Access Compliance Report

Public Rights-of-Way

Intersection ID: 27482	Main Street: GRAHAMWOOD_PL	Cross Street: WILD_ELM_RD	Location: SE
ADA ID: F05242B50DB5	Ramp Type: PerpDiag	Initial Pass/Fail: Fail	Overall Compliance: No
		Severity Score: 25

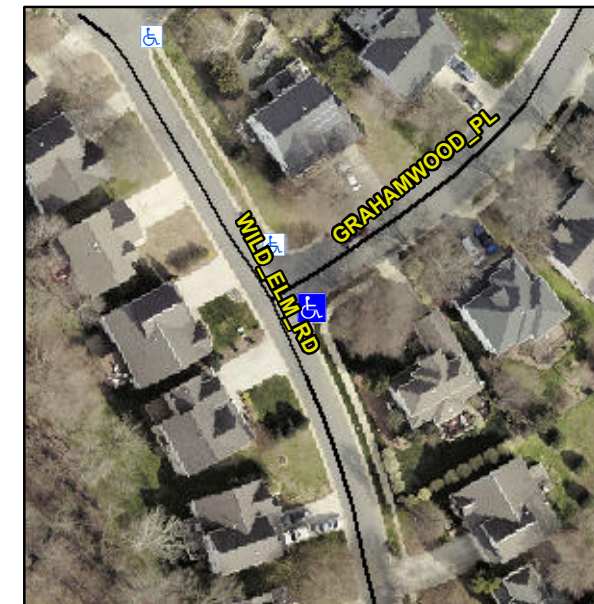
Compliance	Description	Data	Compliance	Description	Data
N/A	Ramp Length (in)	48.0	Yes	Ramp Slope (%)	7.1
Yes	Ramp Width (in)	48.0	No	Ramp XSlope (%)	10.1
N/A	Flare Type LT	N/A	N/A	Flare Type RT	N/A
N/A	Flare Slope LT (%)	N/A	N/A	Flare Slope RT (%)	N/A
N/A	Flare Traversable LT?	N/A	N/A	Flare Traversable RT?	N/A
N/A	Landing Length (in)	N/A	N/A	DWS Provided?	N/A
N/A	Landing Width (in)	N/A	N/A	DWS Contrast?	N/A
N/A	Landing Slope (%)	N/A	N/A	DWS Length (in)	N/A
N/A	Landing X Slope (%)	N/A	N/A	DWS Full Width?	N/A
N/A	Landing Curb? (Y/N)	N/A	N/A	DWS Offset (in)	N/A
N/A	Shared Landing?	N/A			
N/A	Gutter Ponding?	N/A	N/A	Gutter Slope (%)	N/A
N/A	Gutter Lip Ht (in)	N/A	N/A	Gutter X Slope (%)	N/A
N/A	Painted X Walk1?	No	N/A	Painted X Walk2?	No
	X Walk 1 Direction	To N		X Walk 2 Direction	To W
N/A	X Walk 1 Width (in)	N/A	N/A	X Walk 2 Width (in)	N/A
	X Walk 1 Slope (%)	3.6		X Walk 2 Slope (%)	0.6
	X Walk 1 X Slope (%)	4.1		X Walk 2 X Slope (%)	4.7

Remove & Replace Curb Ramp With Two New Directional Ramps or Equivalent.
